REV XT

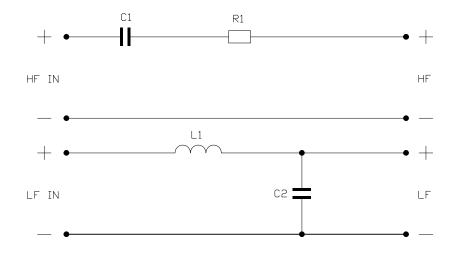
<b>А</b> В	<b>06/08/14</b> 13/10/14	
	LAYOUT AND COMPONENTS ALTERED R1 3R3 WAS R3 OMITTED L1 1.2mH WAS	
	0.7mH C2 12µ WAS	33µ

RESISTOR R2 REMOVED CR 9004
